Road & Bridge Design Publications

Monthly Update – September 2023

Revisions for the month of **September** are listed and displayed below and will be included in projects submitted for the **January** letting.

DETAIL
7

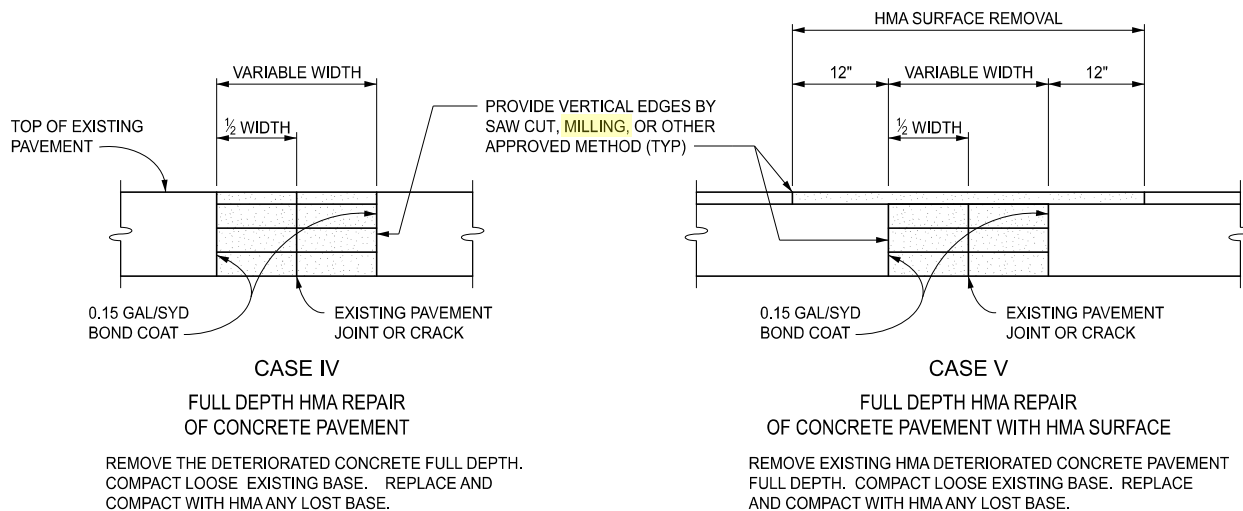
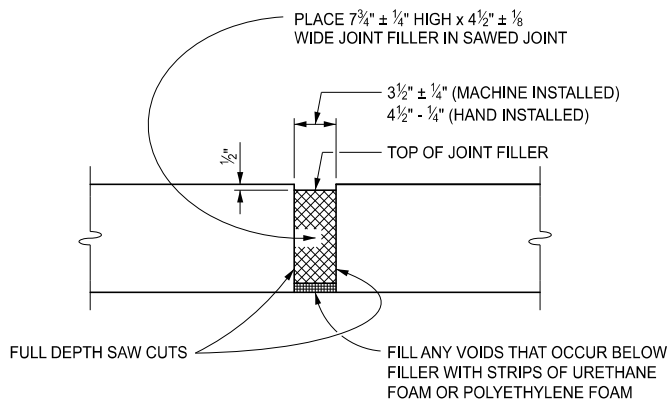
R-44-G: Concrete Pavement Repair: Added “milling” as an alternate method for providing vertical edges for Detail 7 and Detail 8 joint repairs. Also added “other approved material” as an alternate for the removed material in Cases IV and V for Detail 7 and Detail 8 joint repairs.

FOR CASES IV, & V, THE REMOVED MATERIAL SHALL BE REPLACED WITH A HMA TOP COURSE MIXTURE, OR OTHER APPROVED MIXTURE. THE HMA SHALL BE COMPACTED WITH A MACHINE VIBRATOR OR APPROVED ROLLER WITH BASE LIFT THICKNESSES NOT TO EXCEED 3" AND WITH THE TOP LIFT THICKNESS NOT TO EXCEED 2". THE FINAL SURFACE OF THE REPAIR SHALL BE FLUSH WITH THE EXISTING PAVEMENT SURFACE.

TERMINAL END SHOE,
TYPE A, TYPE B OR TYPE MGS

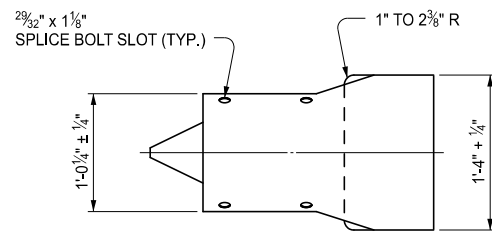
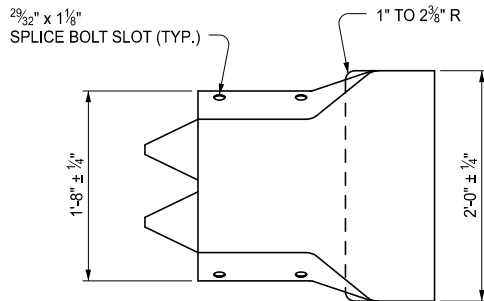
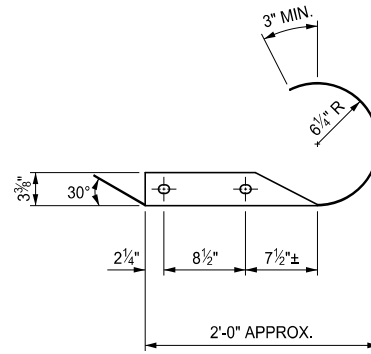
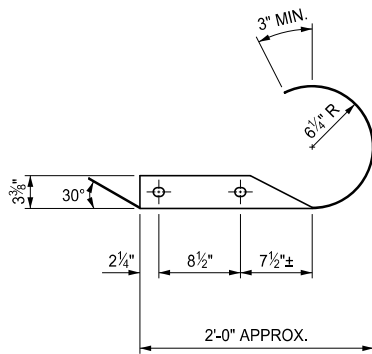
R-66-E: Guardrail Departing Terminal Types B, T, & MGS: Revised the title of the detail for the terminal end shoe to include “Type A” guardrail.

PLAN AT SKEW
(APPROXIMATELY 15 DEGREES OR MORE)

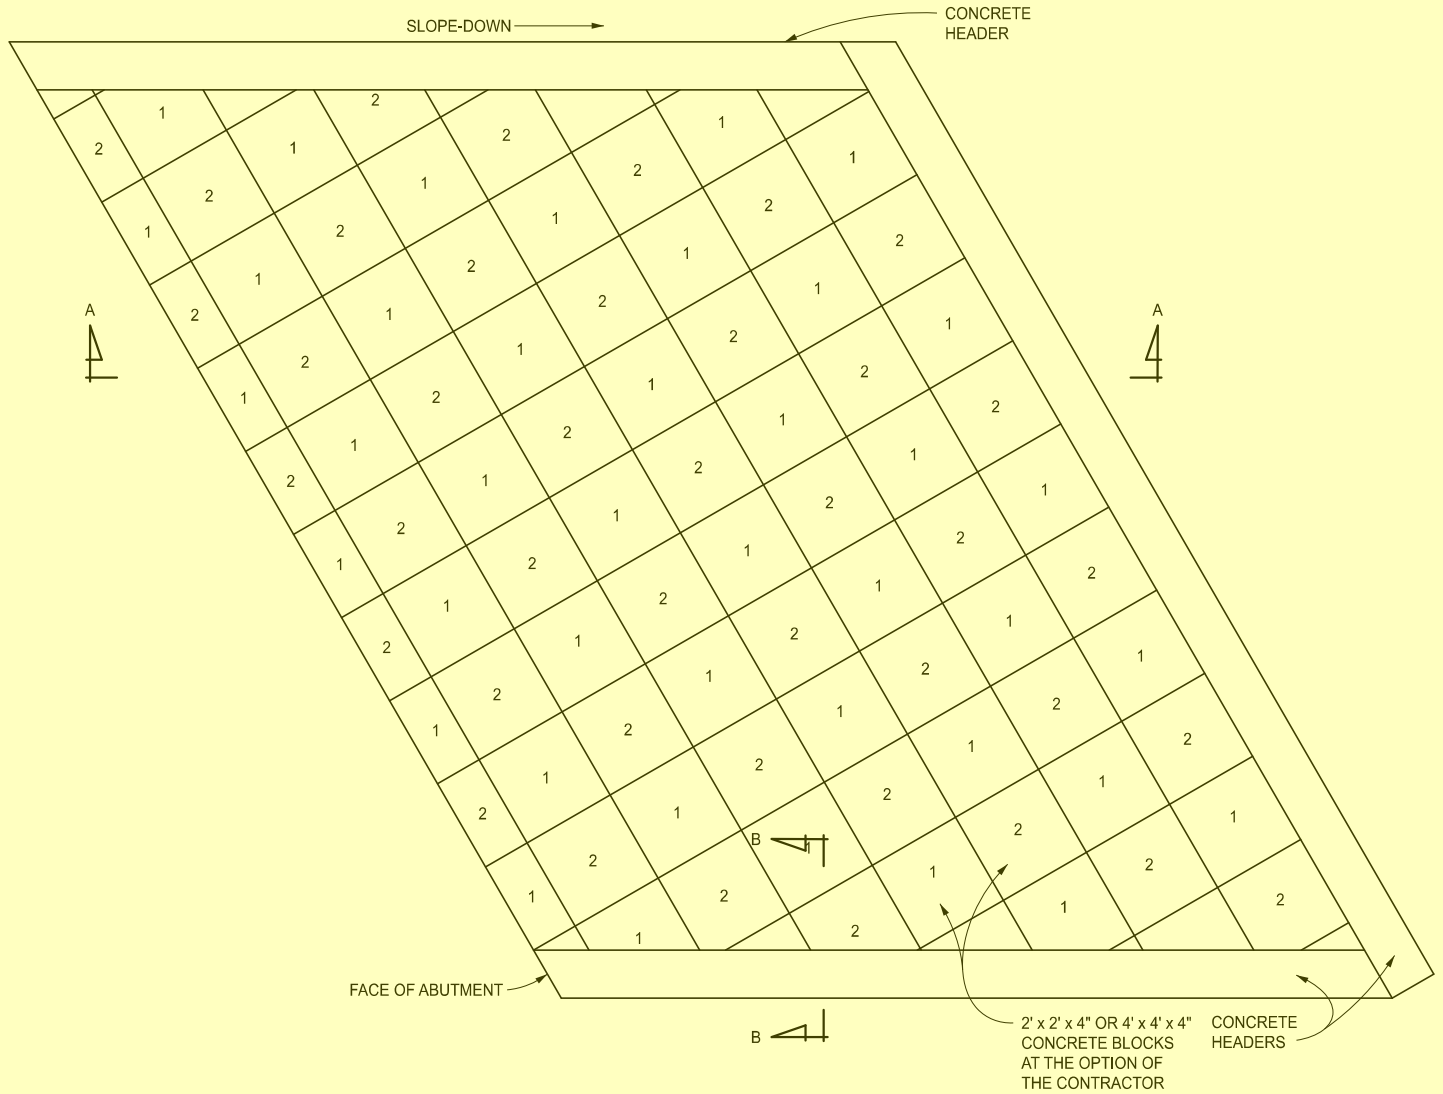
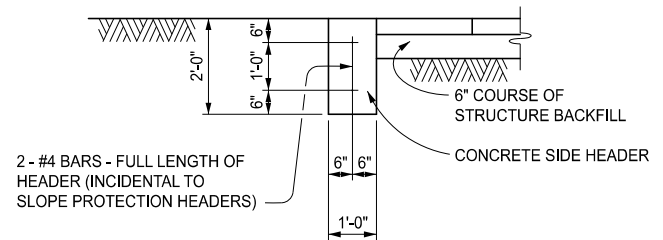
B-102-D: Added a detail for placing slope paving at skewed structures. Updated the pour sequence and added alternate pour sequences.
